# GENERAL ELECTRIC

SUBJECT: SUMMARY OF AUGUST 5, 1980 NRC/GE MEETING ON CORE SPRAY  
DESIGN METHODOLOGY

BWR CORE SPRAY DESIGN

COMPARISON OF LOWEST MEASURED FLOWS

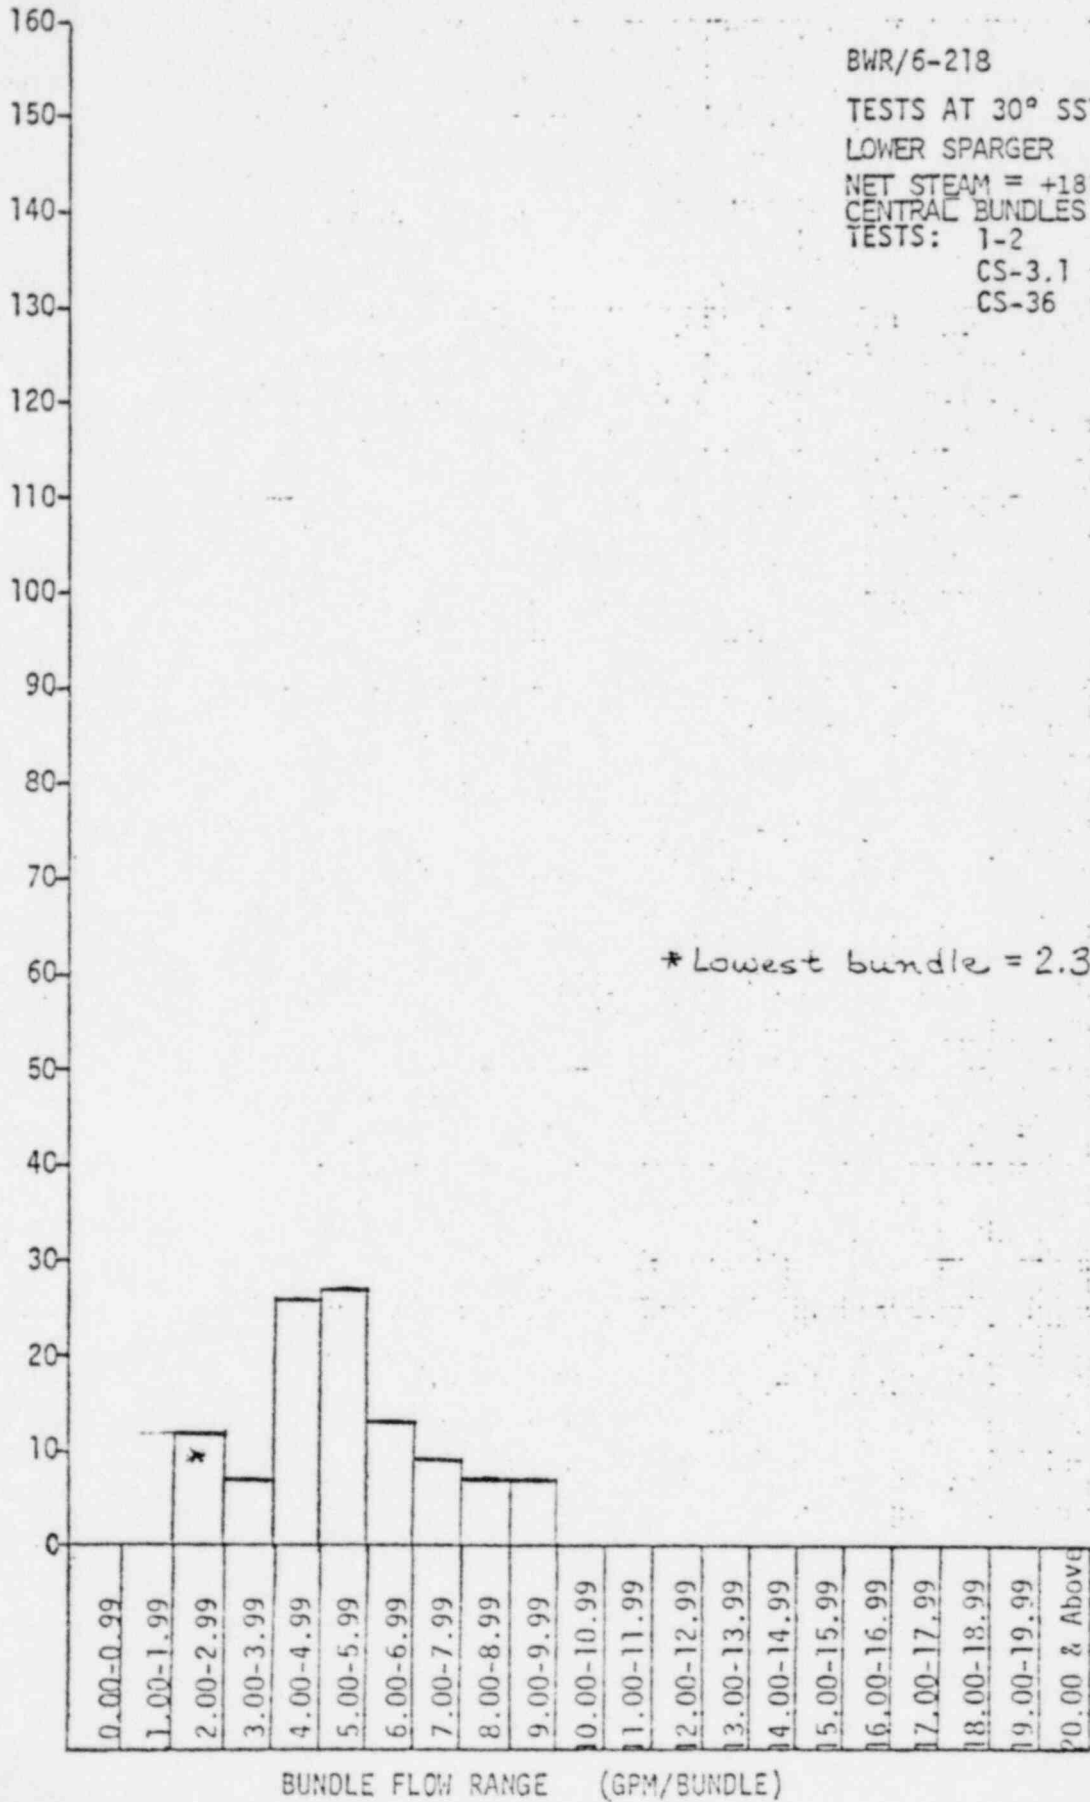
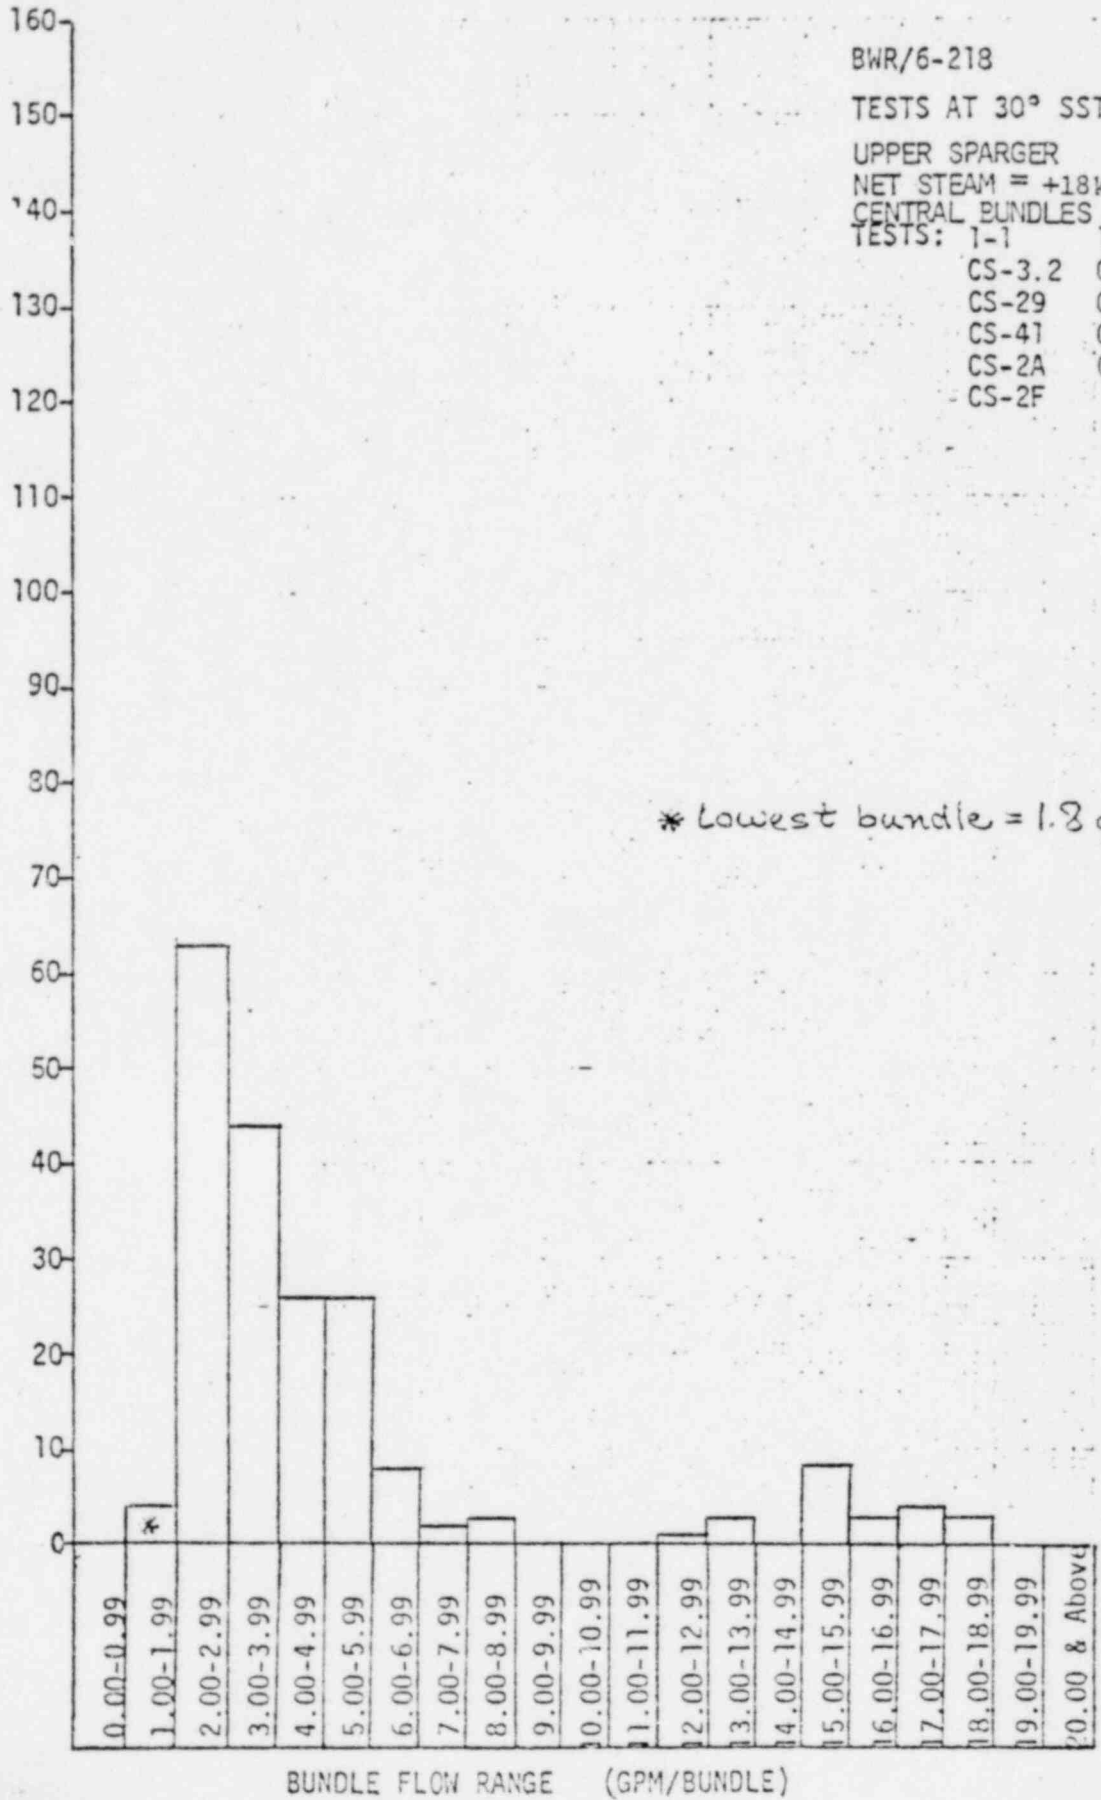
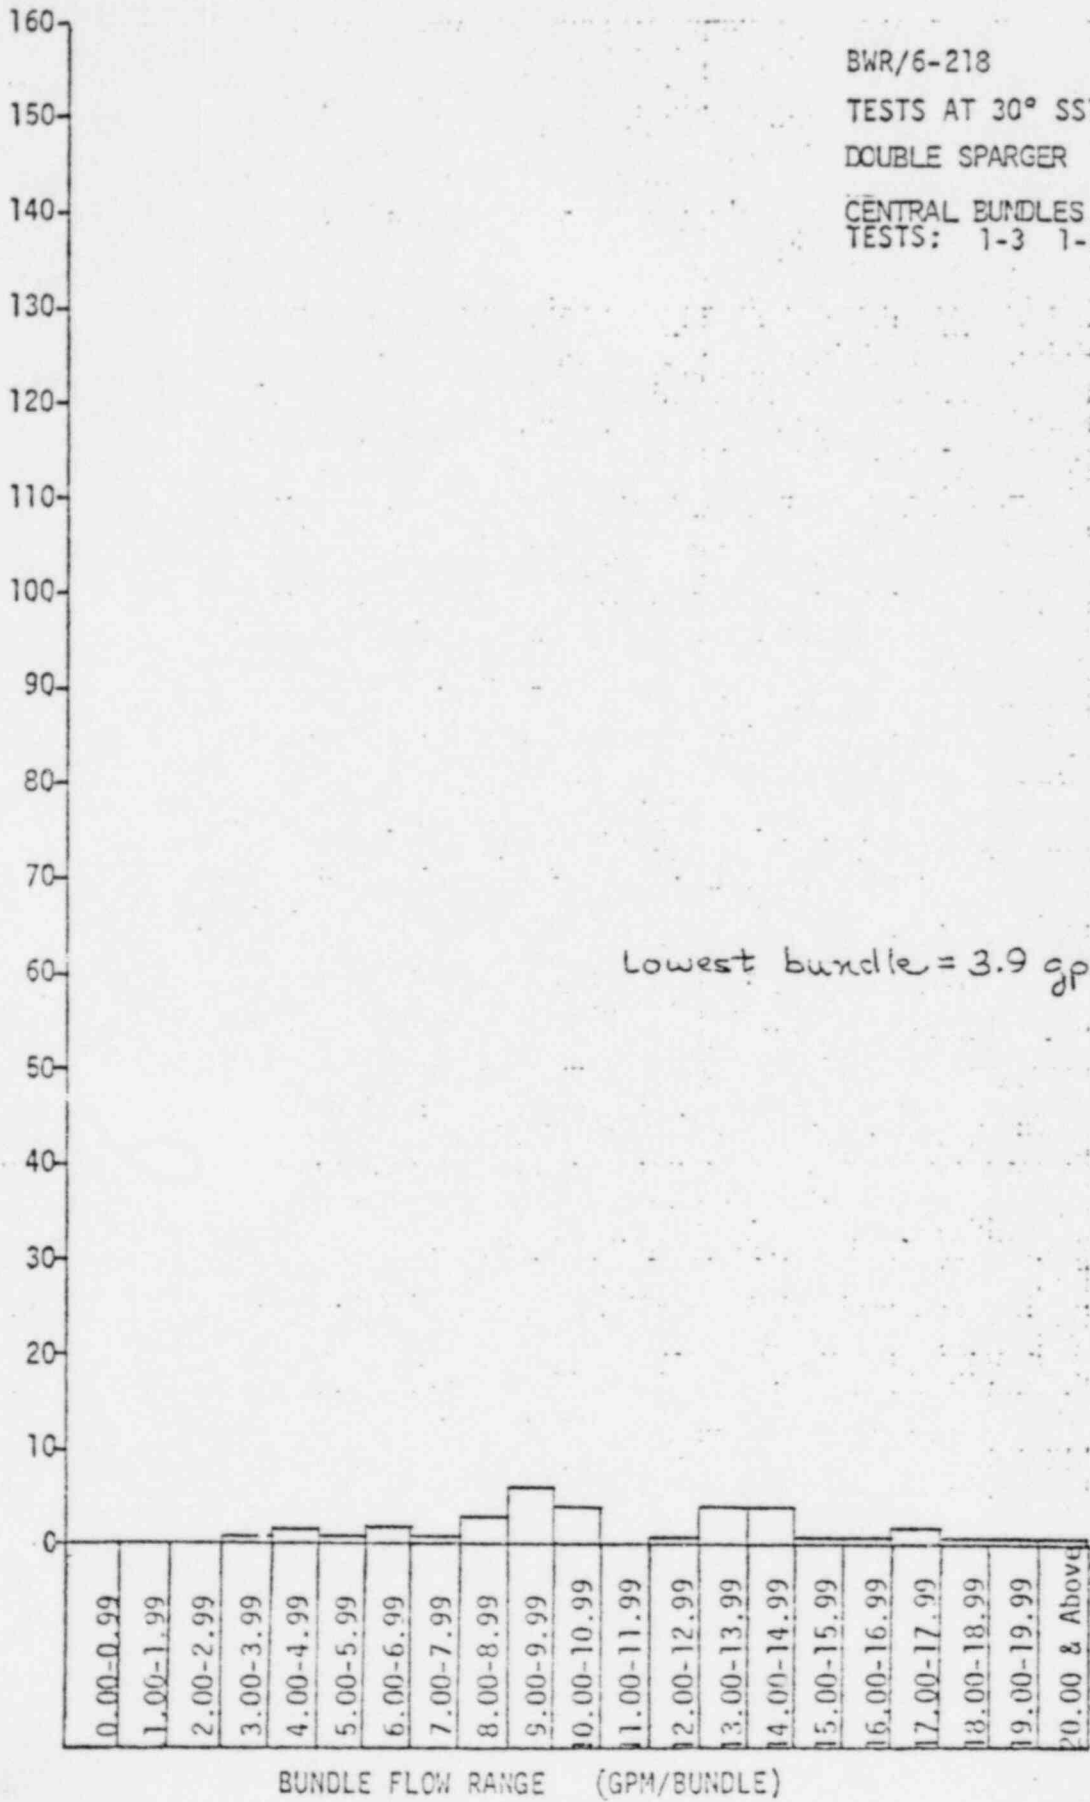
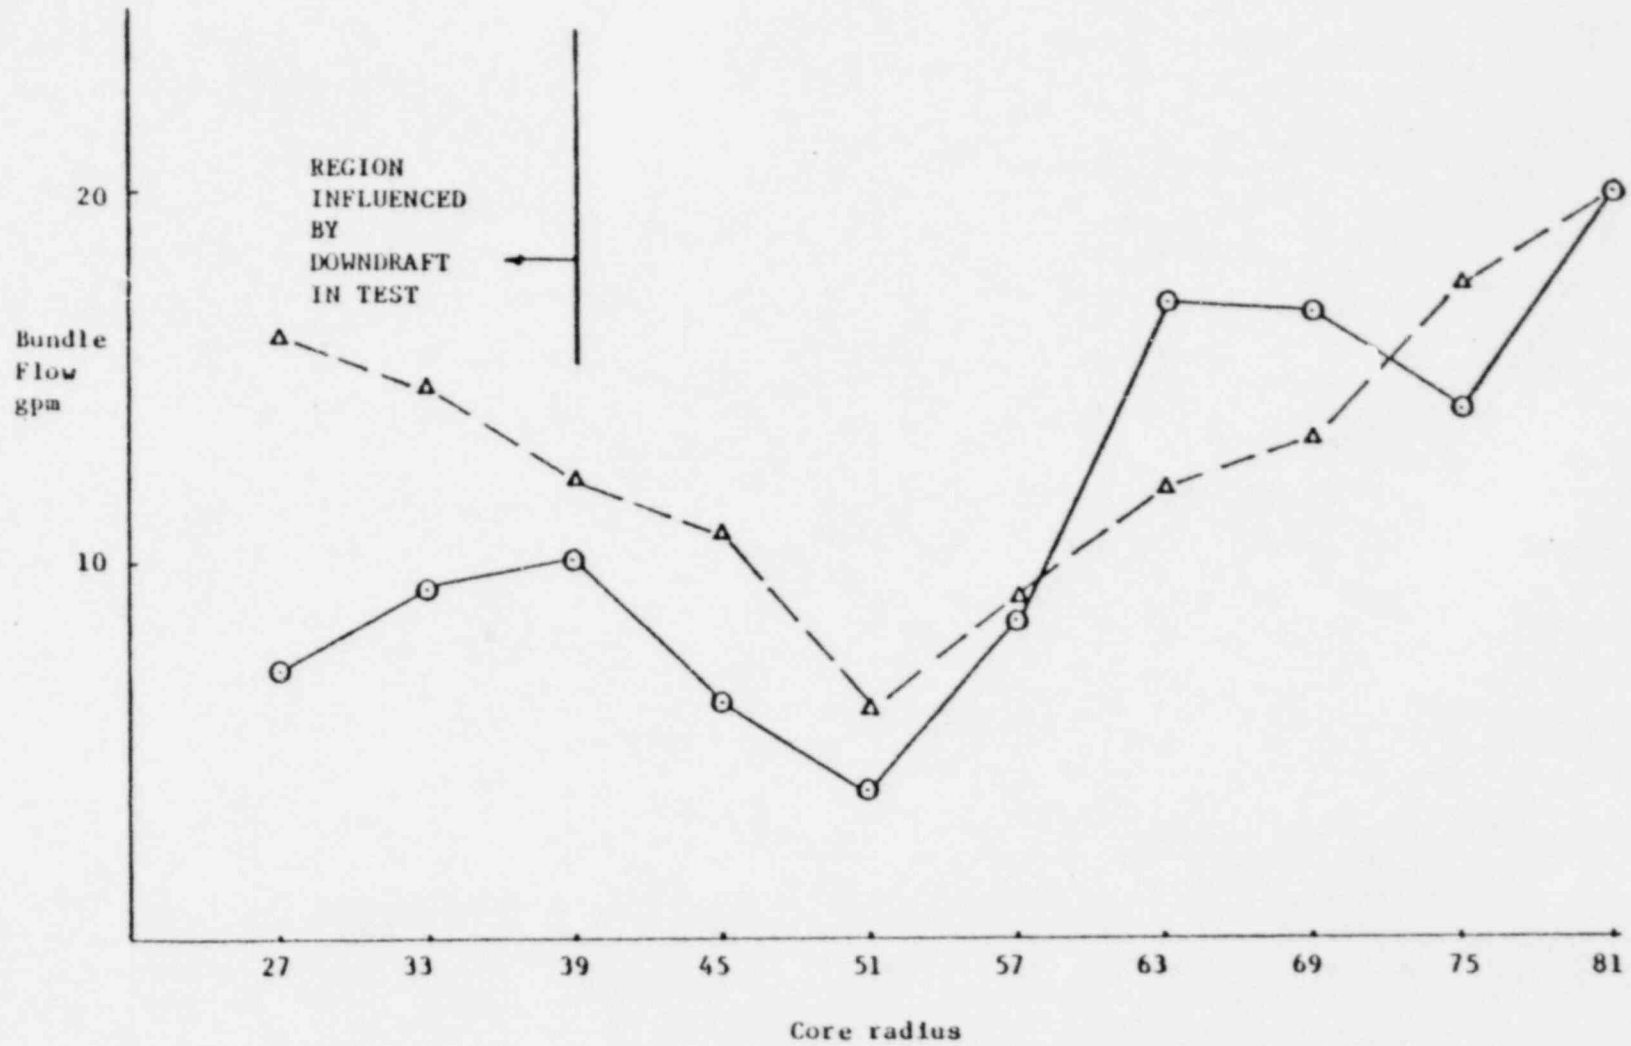
SINCE THE DOUBLE HEADER INDIVIDUAL BUNDLE FLOWS ARE NOT THE SUPERPOSITION OF SINGLE HEADER FLOWS, DOES THIS MEAN THAT THE LOWEST FLOW FOR DOUBLE HEADER WILL NOT BE THE SUM OF THE LOWEST FLOWS FOR SINGLE HEADERS?

DOUBLE HEADER INTERACTION EFFECTS CAUSE SOME BUNDLES TO RECEIVE MORE FLOW THAN SUPERPOSITION OF SINGLE HEADER FLOWS, AND SOME BUNDLES LESS. THIS IS SEEN IN BOTH STEAM AND AIR DATA. HOWEVER DATA FOR BOTH STEAM TESTS AND AIR SIMULATOR TESTS SHOW LOWEST BUNDLE FLOW FOR THE DOUBLE HEADER IS APPROXIMATELY EQUIVALENT TO THE SUM OF LOWEST BUNDLE FLOWS FOR SINGLE HEADERS,

- o SUPERPOSITION DOES NOT APPLY FOR ALL LOCAL BUNDLES
  - SIMILAR RESULTS FOR AIR AND STEAM COMPARISONS

- o SUM OF SINGLE HEADER VALUES IS GOOD ESTIMATE OF CORE MINIMUM FLOW FOR DOUBLE HEADER
  - CONSISTENT FOR AIR AND STEAM COMPARISONS
